# UNITED STATES PATENT AND TRADEMARK OFFICE

APPLICATION NO.	FILING DATE	FIRST NAMED INVENTOR	ATTORNEY DOCKET NO.	CONFIRMATION NO.
10/648,937	08/26/2003	James L. Hadder	H0004989	5923

## FINAL REJECTION

Figures 4 and 5 of Liebe

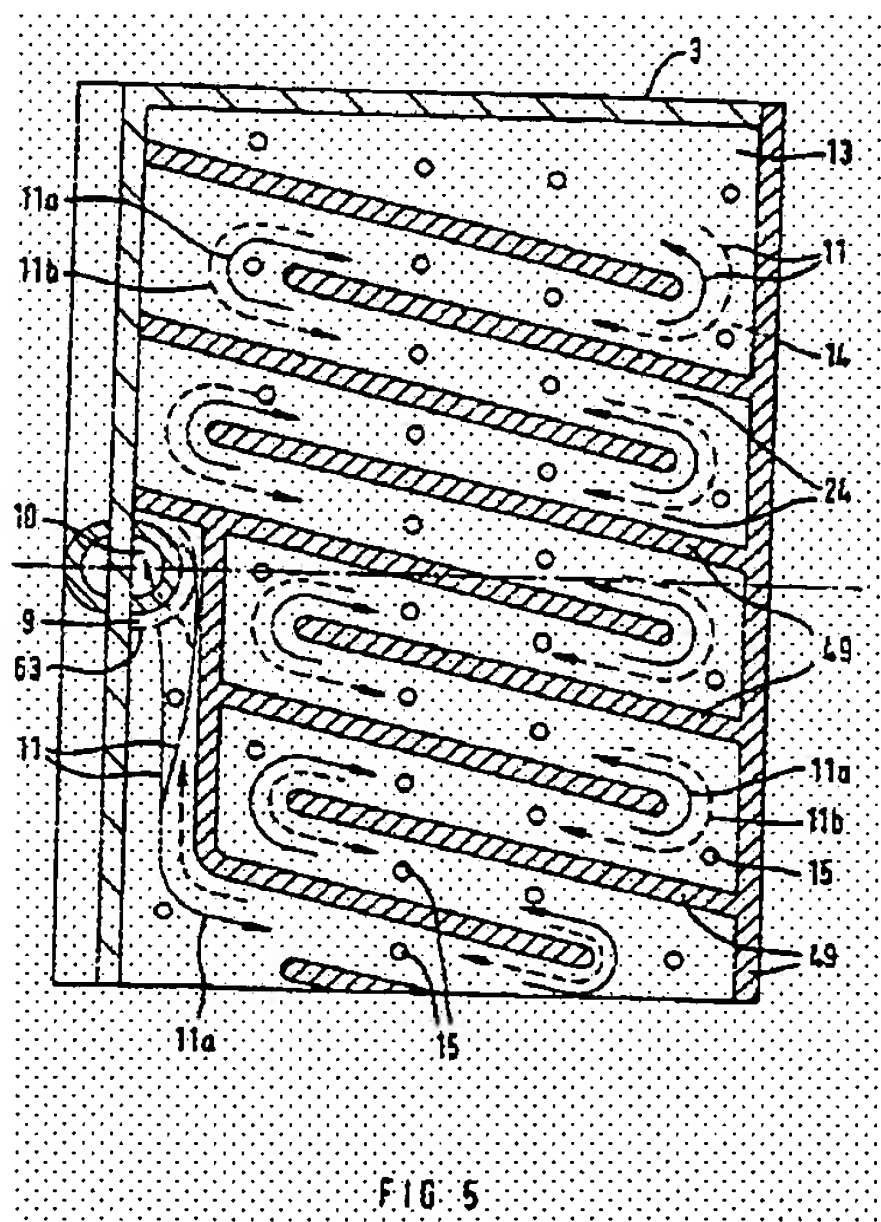
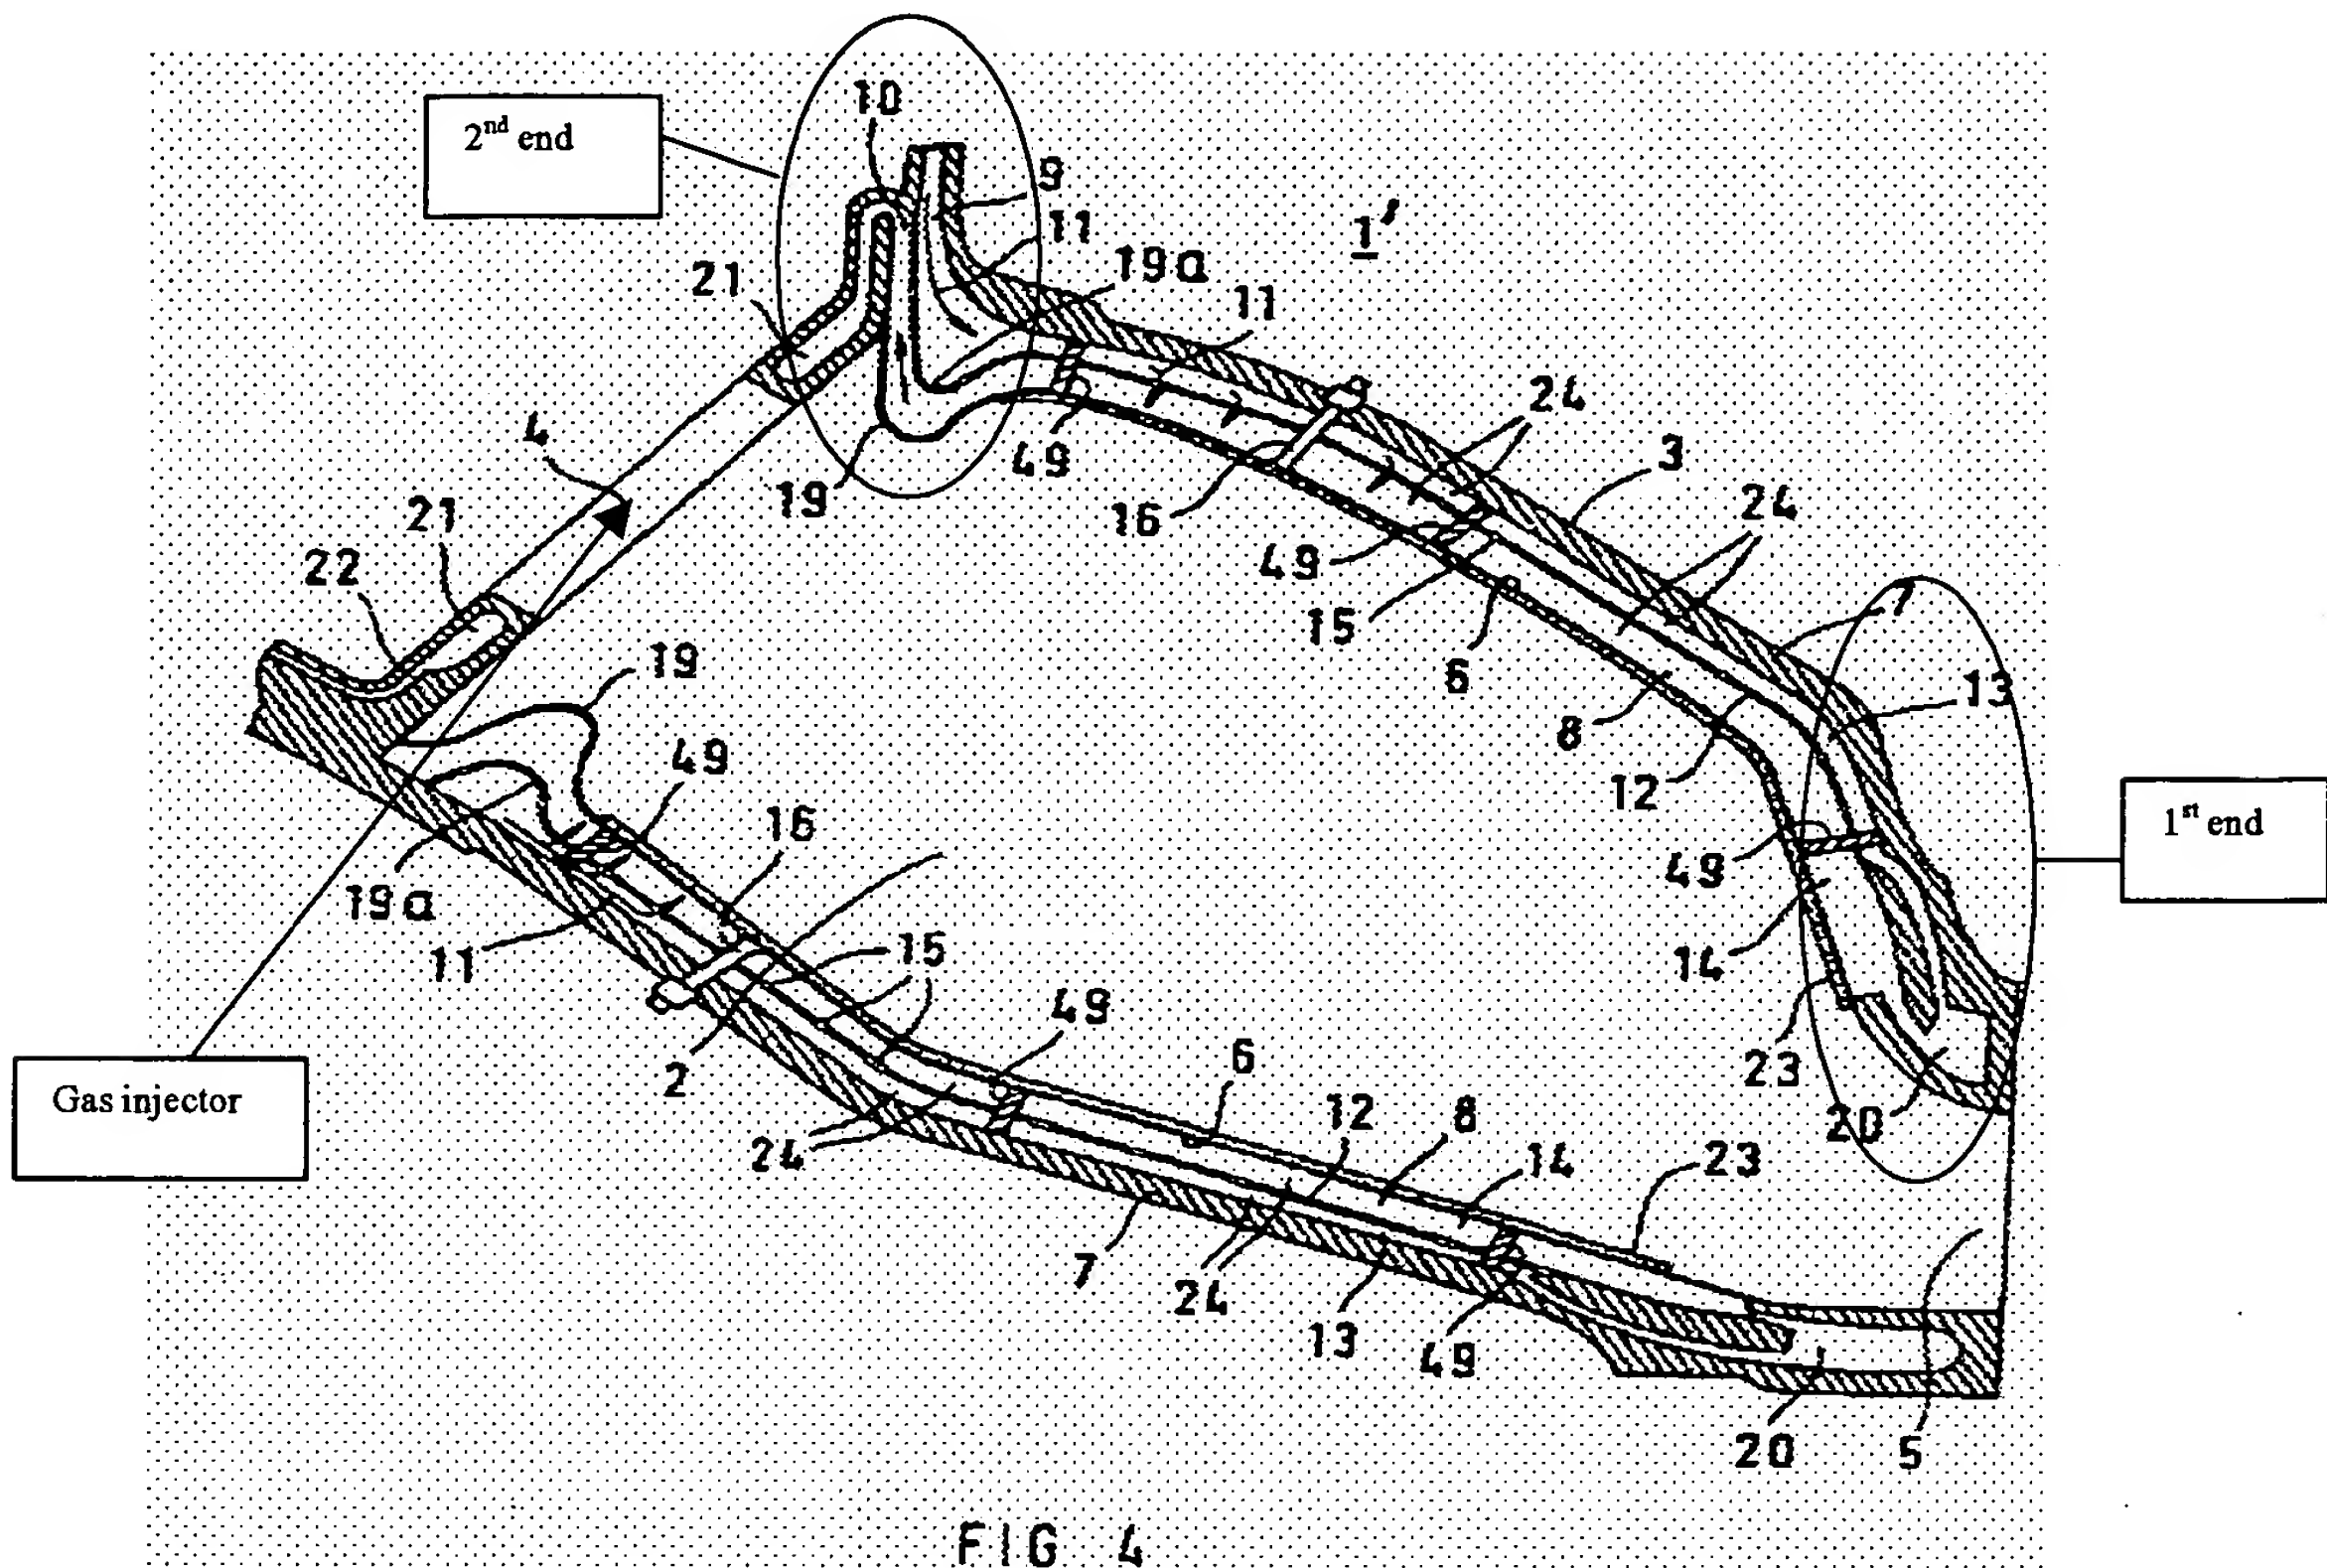
With respect to claim 14, **Liebe** teaches a cooling tube assembly for cooling a liner (3, 6) of a combustor chamber of a gas turbine engine, the assembly comprising: a plurality of serpentine cooling tubes (13, 14), each serpentine tube conforming to a contour of the liner, each serpentine tube including: a first end in fluid communication with a plenum located proximate and exhaust end of the combustion chamber, and a second end in fluid communication with an area in proximity with a gas injector of the gas turbine engine located proximate an intake end of the combustor chamber, each serpentine cooling tube supported by a plurality of pins 16 to maintain the serpentine cooling tube at a spaced distance from the liner, and each pin 16 having a proximal end attached to the cooling tube and a distal end inserted through the liner. See particularly **Figures 4, 5** of **Liebe** above.

With respect to claim 16, **Liebe** teaches that the cooling tube 14 is positioned on an exterior side of the liner 6. See particularly **Figure 4** of **Liebe**.

With respect to claim 17, **Liebe** teaches that the cooling tube 13 is positioned on an interior side of the liner 3. See particularly **Figure 4** of **Liebe**.

With respect to claim 18, **Liebe** teaches that the serpentine shape of each tube is formed as a plurality of alternating bends along a length of each tube. See particularly **Figure 4** of **Liebe**.

With respect to claim 10, **Liebe** teaches that the cooling tube 14 is positioned outside the combustor chamber liner 3. See particularly **Figure 4** of Liebe.

With respect to claim 12, **Liebe** teaches the cooling tube assembly is in contact with the liner (3, 6). See particularly **Figure 4** of Liebe.

With respect to claim 13, **Liebe** teaches that the cooling tube is maintained a spaced distance from the liner. See particularly **Figure 4** of Liebe.
